Re: Response to Request for Additional Information (TAC No. MA6134), Docket
No. 50-20, License No. R-37.

Response to TAC No. MA6134

Information on Patient Safety During Use of FCB Facility

Drawings of FCB Shutters

Fission Converter Irradiation Control Logic

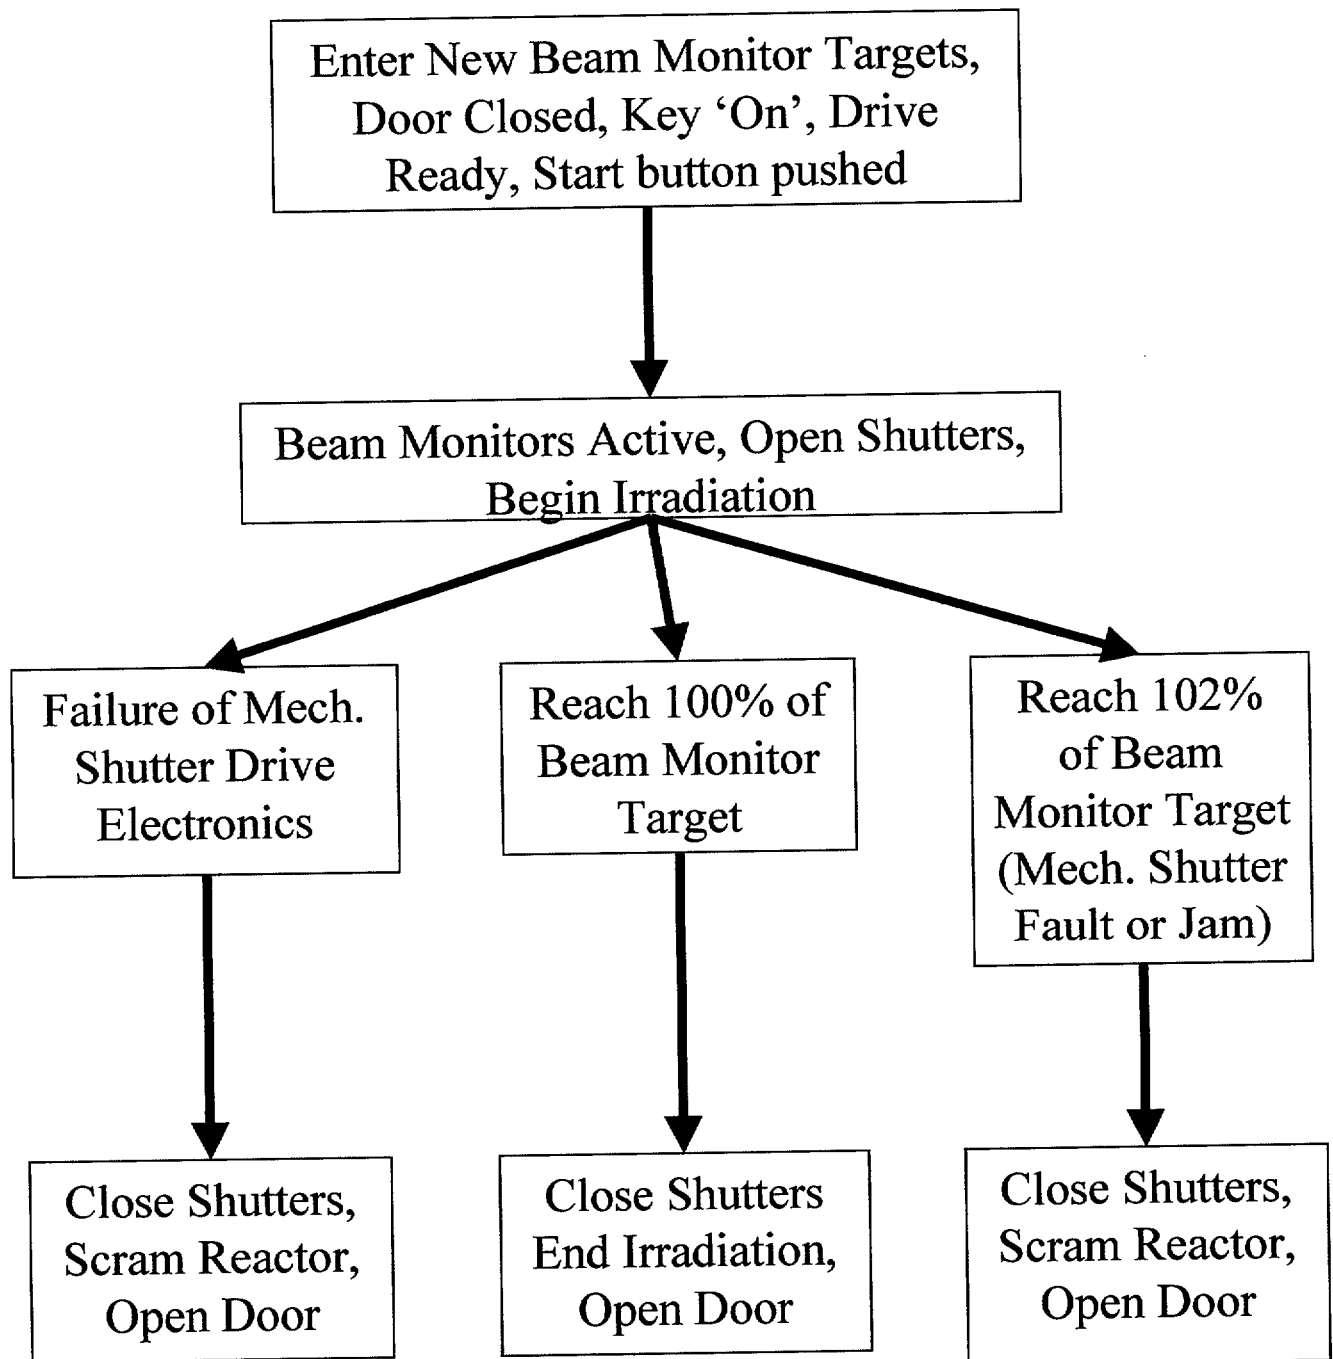
11. Appendix A to this response is entitled, "Information on Patient Safety During Use of FCB Facility." These calculations were prepared by Professor Harling and the senior staff of the fission converter project. It provides information on the fission converter irradiation control logic, anticipated radiation levels (rad/minute) for both 5 and 30 minute patient irradiations, and an analysis of various failure scenarios including failure of both the mechanical and water shutters. Note that both the 5 and 30 minute irradiations assume the delivery of a tolerance dose of 1200 RBE-cGy. Listed below are responses to the subitems requested on TAC No. 11.

Scenario A

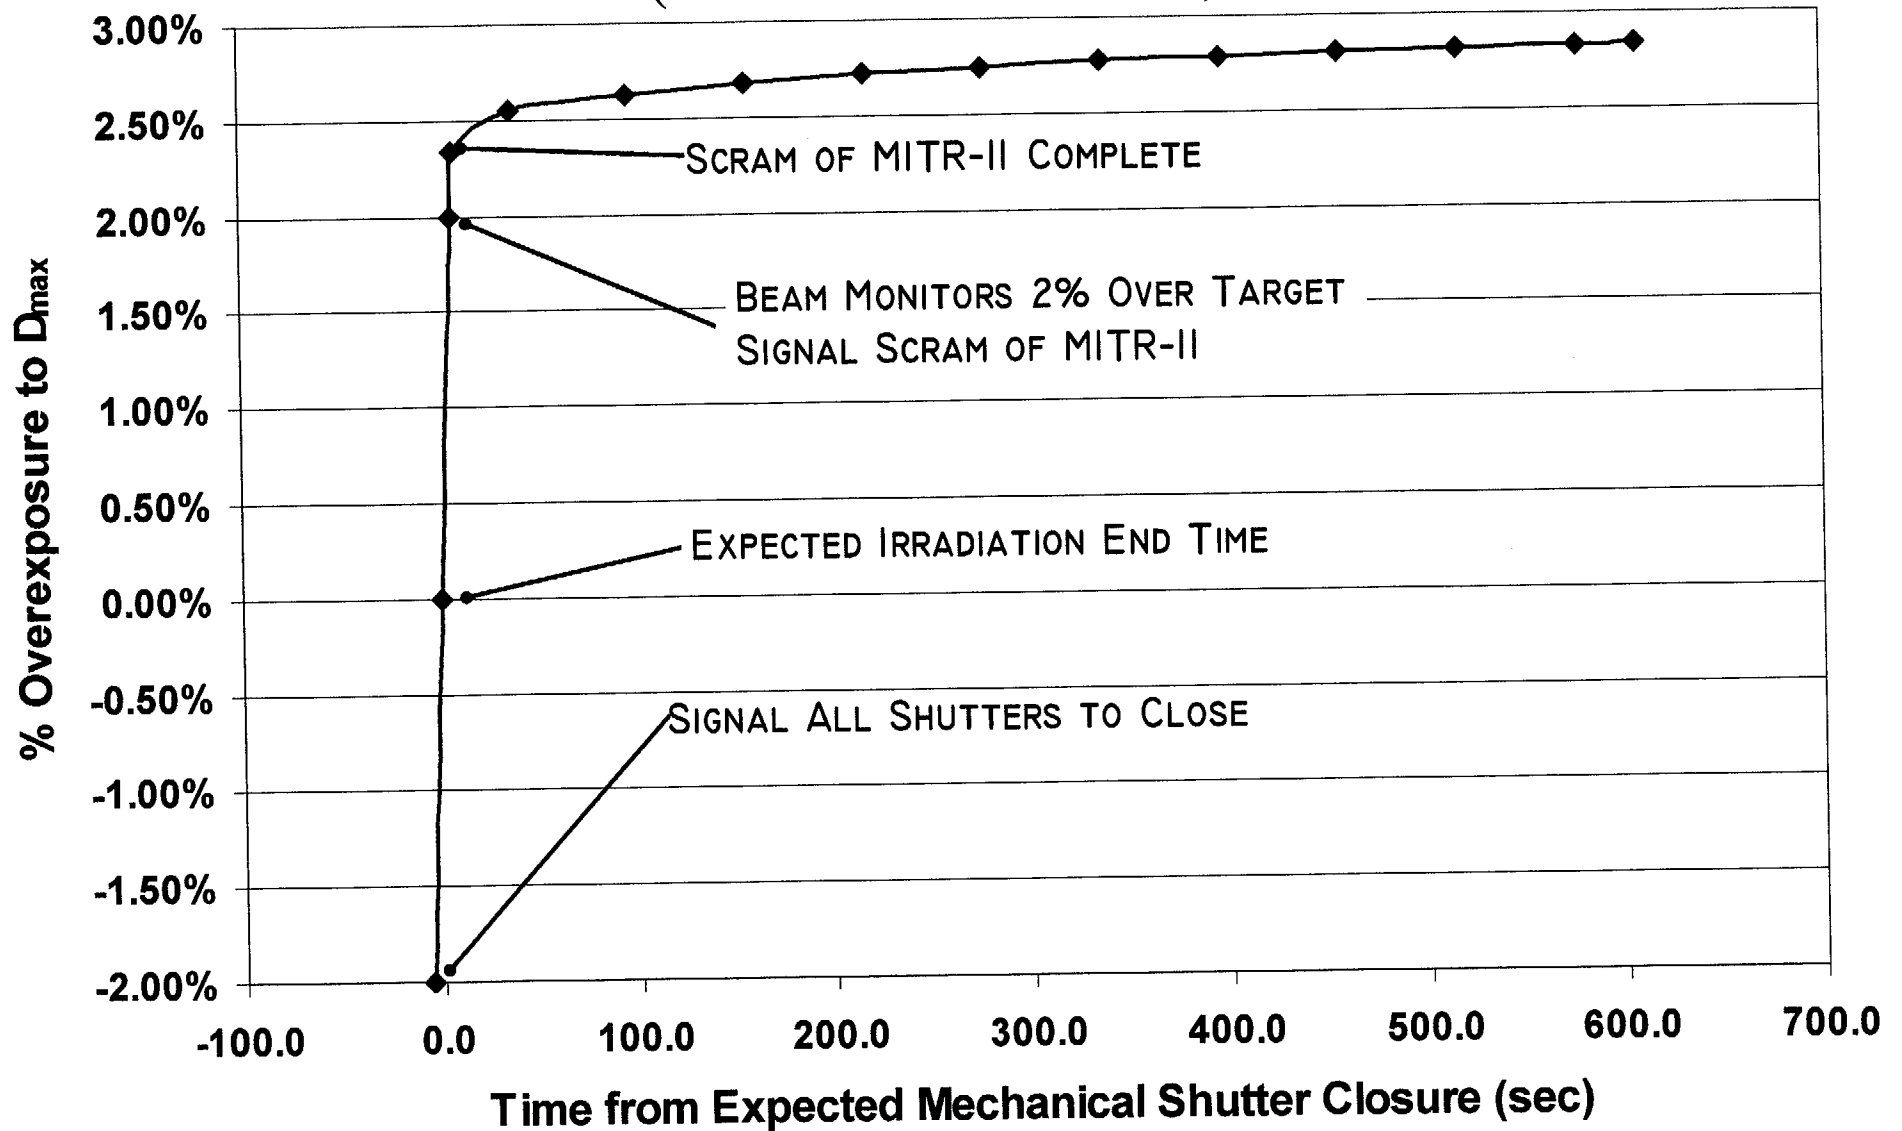
- This worst case scenario leads to a maximum patient overexposure of 2.7%
- In this worst case scenario, the mechanical shutter fails such that it cannot be closed
- The Beam Monitoring System (BMS) accumulates 2% excess counts (6 seconds for a 5 minute irradiation) and then automatically scrams the MITR, reducing the dose rate by two orders of magnitude. The BMS has redundant, independent circuits and is backed up by separate uninterruptible power supplies.
- The water shutter closes in 100 seconds which provides another factor of 10 in gamma attenuation. Delayed neutrons have also decayed to negligible levels during this time. At this point the dose rate in the direct beam is ~ 0.019 Eq. Rad/min.
- Once the reactor has scrammed and the water shutter has filled, the patient could remain in the room up to $0.1 * 1200 / 0.019 = 6300$ minutes before approaching a 10% overexposure.

FRONT VIEW OF MECHANICAL SHUTTER

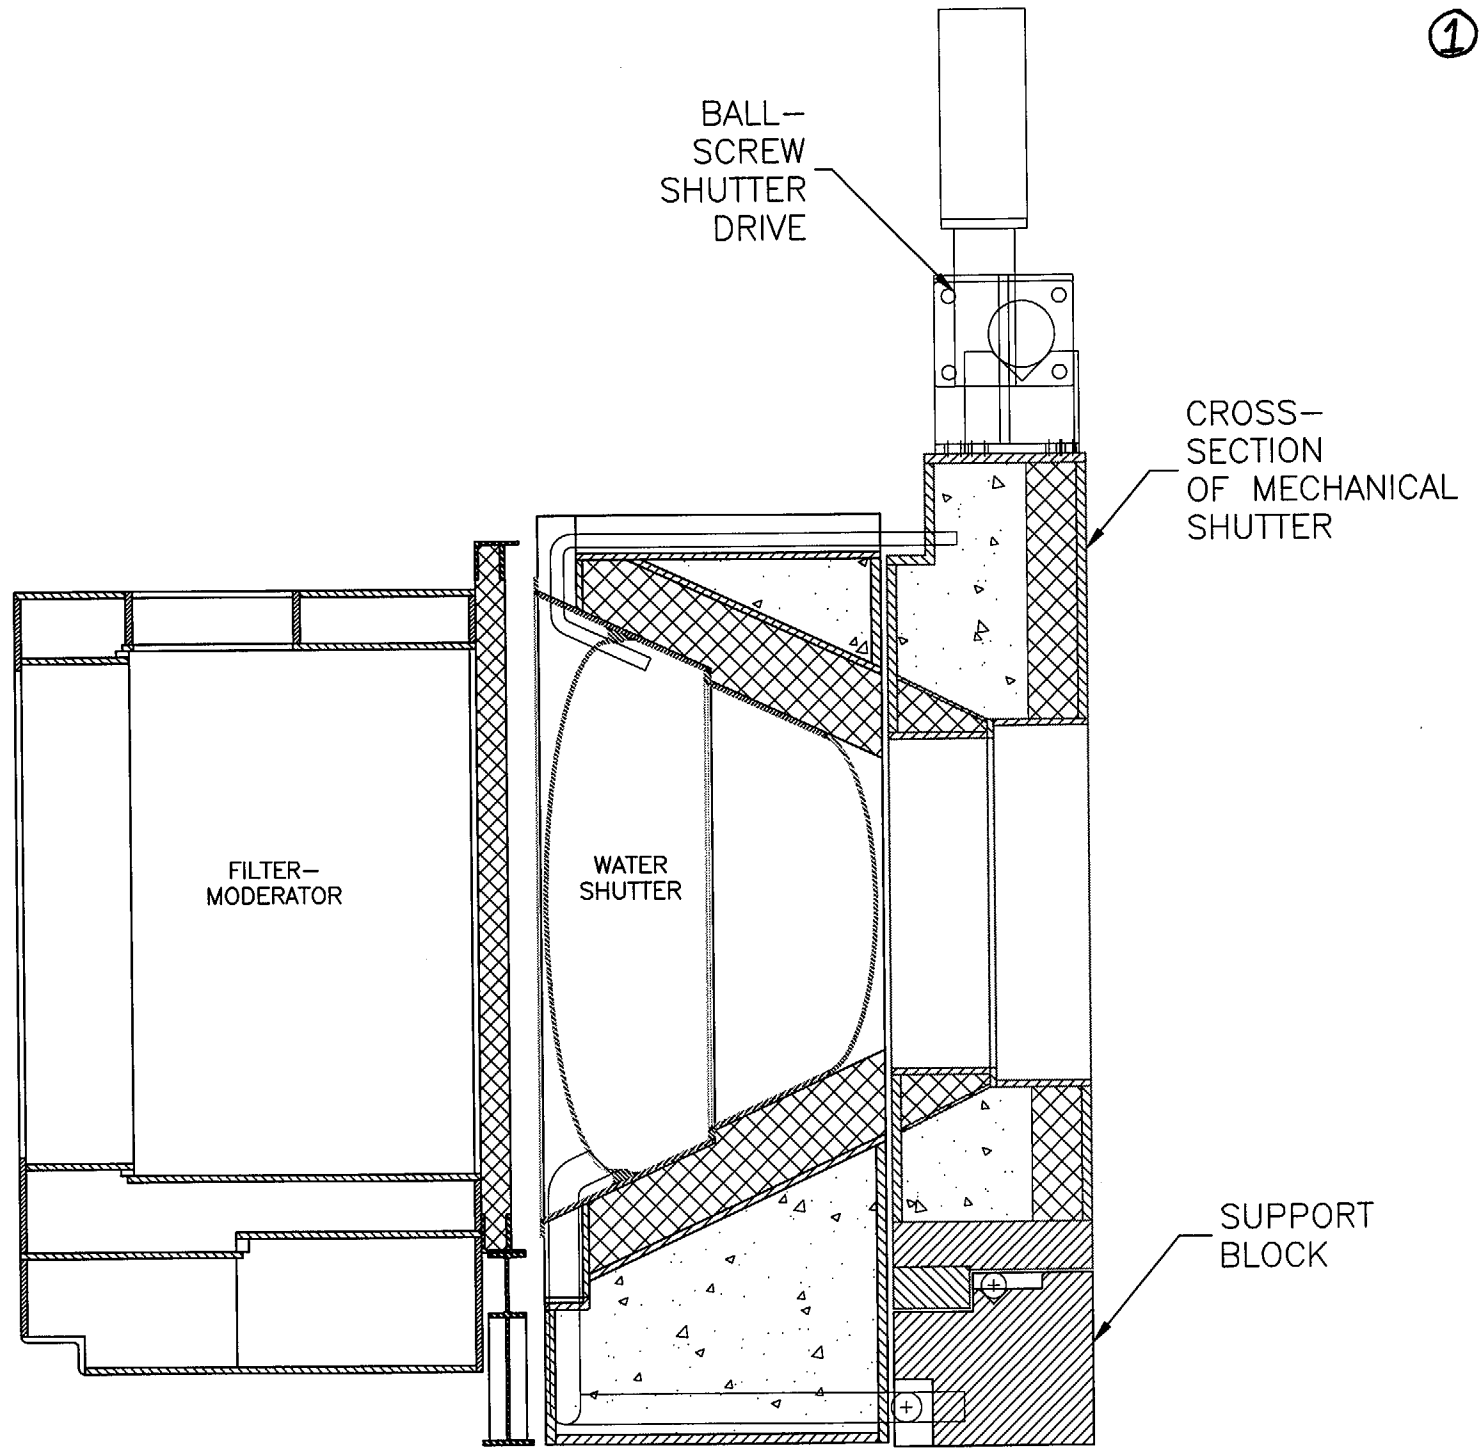
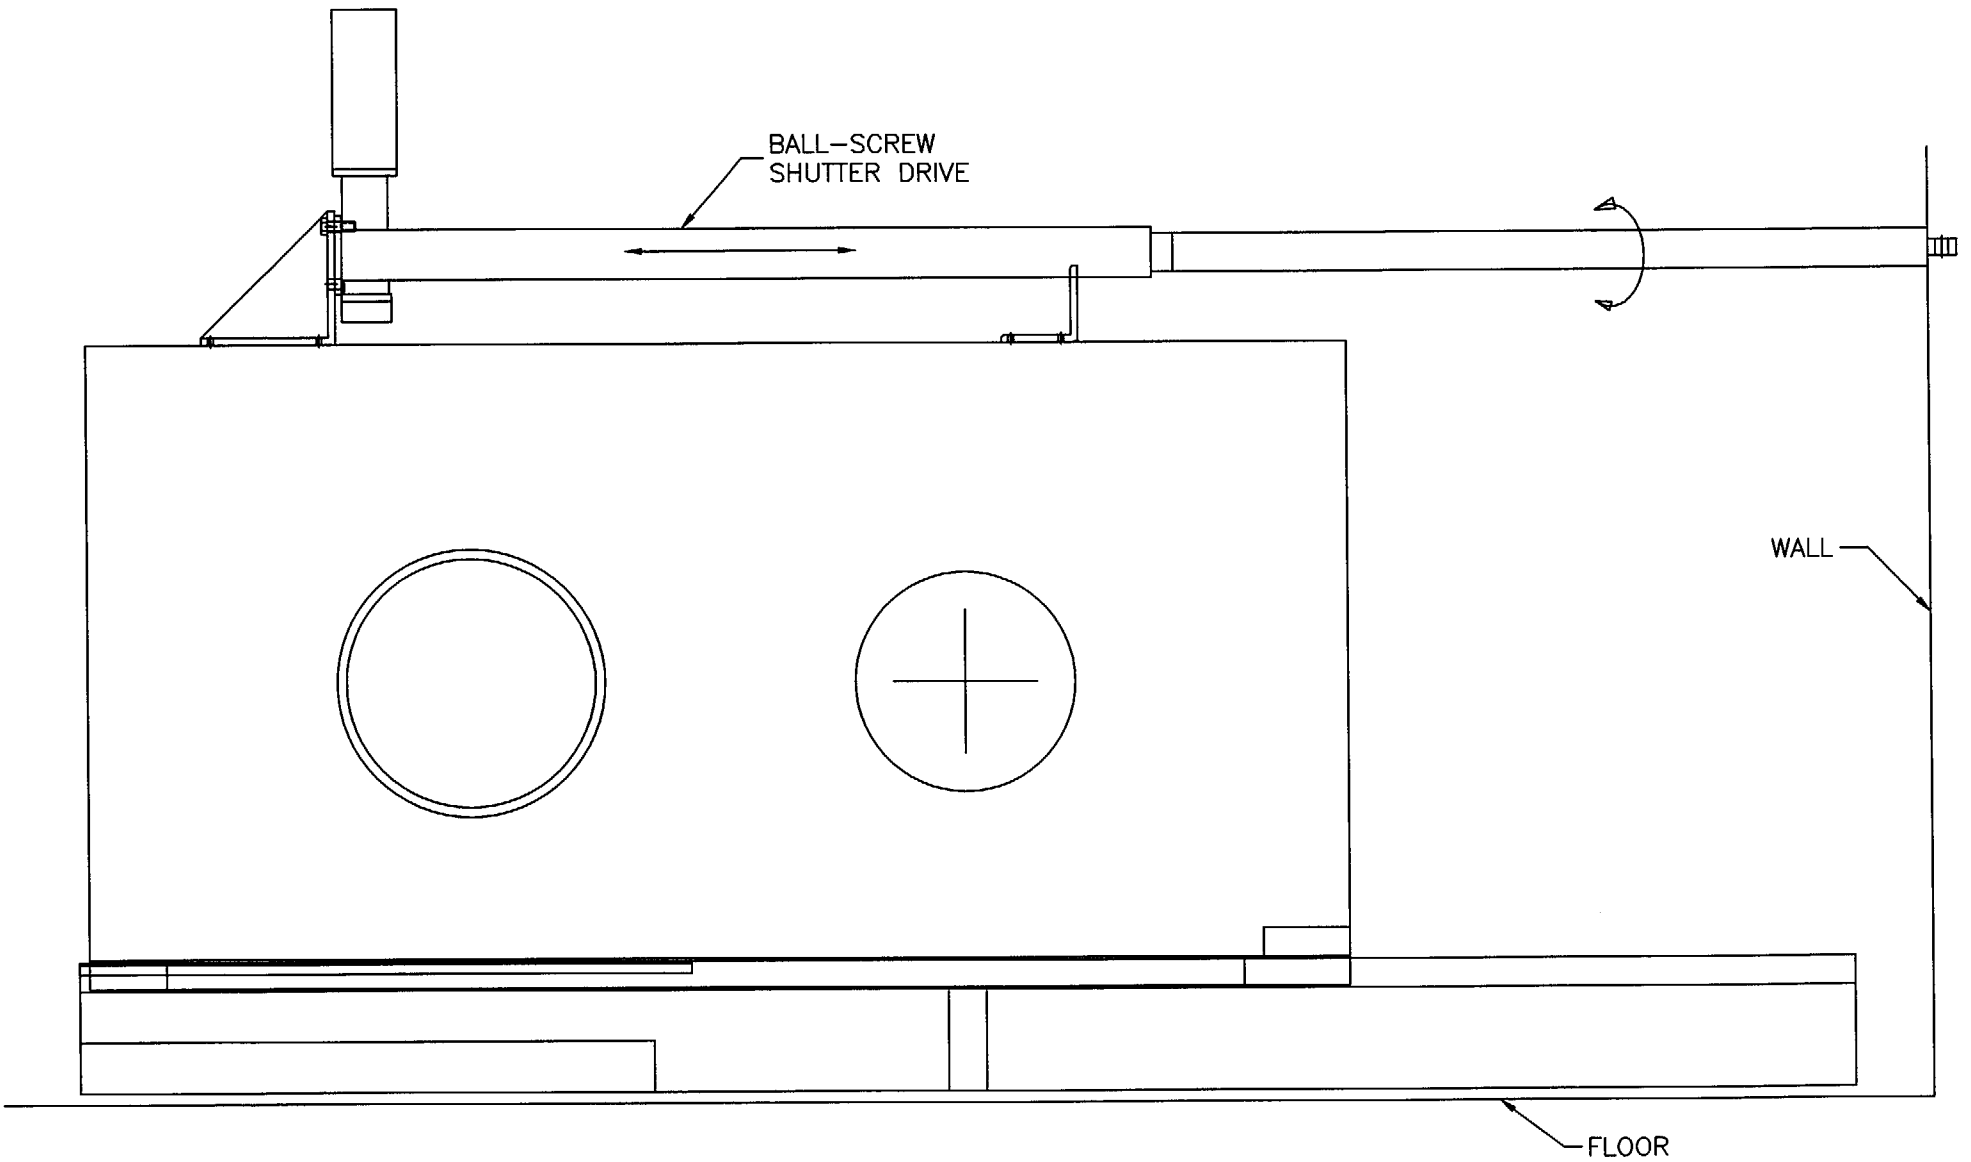
14. Drawings of the components listed in TAC Question Nos. 14(a) - 14(f) are included as an attachment to this response. Please refer to Appendix B. There are no common components to the two shutters that control beam delivery with the exception of electrical power. As described in our response to TAC Questions No. 1, 2, and 11, fail-safe provisions exist to ensure both patient and staff safety in the event of loss of electrical power. The staff would become aware of a loss of motive power to a shutter by the occurrence of the associated fail-safe action (shutter-closure or reactor scram). Failure of a shutter for other reasons (e.g., foreign material precluding movement) would be detected by the redundant beam monitor system which would generate an automatic reactor scram. The indicator lights would also show a failure when shutter closure was attempted and did not give the desired result. If electrical power were lost to the facility as a whole, the activation of the emergency power system would be a further indication.
